**Greetings: Mayor Dean J. Trantalis
Vice Mayor Heather Moraitis
Commissioners: Steven Glassman, Robert L. McKinzie, Ben Sorensen, and City
Manager, Chris Lagerbloom**

**GRAPHIC PRESENTATION
of the
LANDSCAPE & TREE PRESERVATION**

**CITY OF FORT LAUDERDALE
UNIFIED LAND DEVELOPMENT REGULATIONS (ULDR)
SECTION 47-21 LANDSCAPE & TREE PRESERVATION**

Comment # 3 Minimum soil volume requirements

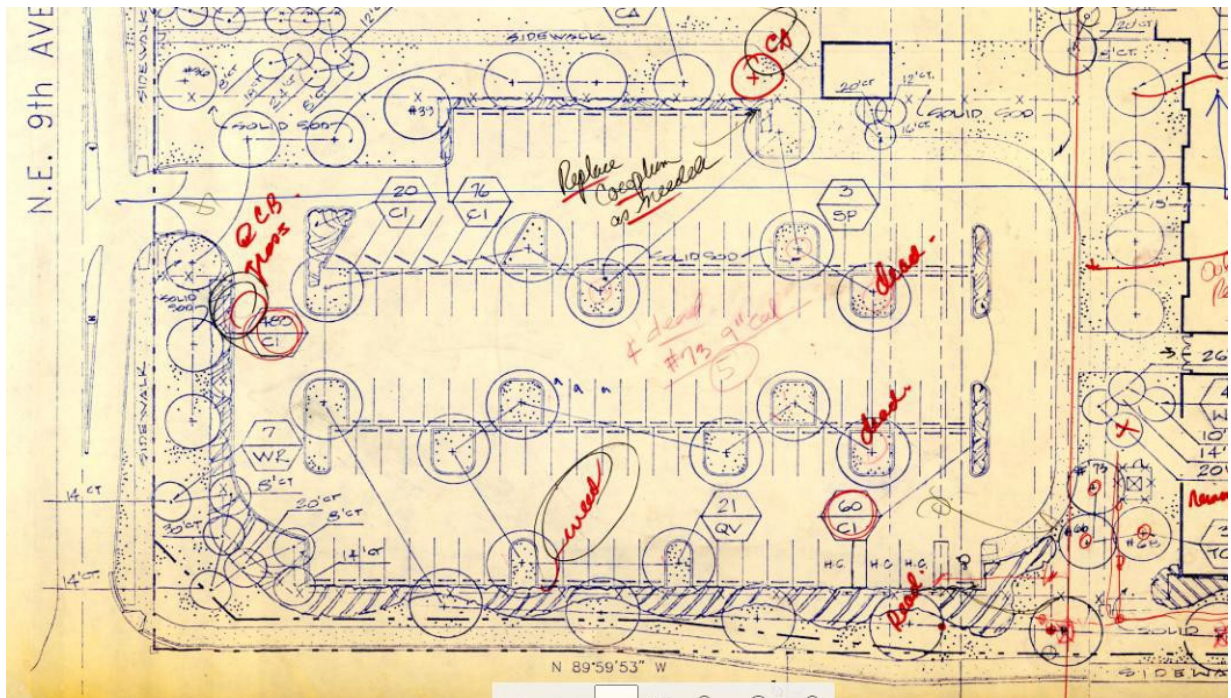
AG comments:

- Current code sets minimum areas and dimensions: Large/Medium/Small trees which based on the code required excavation of 24" deep and the shallow root system of the South Florida trees seems unreasonable..
- The current code sets requirements for new soil to be similar in pH.Texture, to existing soils.
- Where minimum soil volumes cannot be provided most landscape areas will require the use of Structural soil, modular pavement systems or root barriers which is anticipated to cost development of each landscape area approximately \$5,000 to \$8,000 per Large/Medium tree.

AG Recommendation:

Delete minimum soil volume requirements from the Ordinance. Consider the following:

- Increase the dimensions of all landscape areas where large/Medium trees are to be installed.
- Increase the interior (VUA) landscape area for each Interior space.
- Decrease the soil volumes based on depth of soil required for South Florida Tree roots.
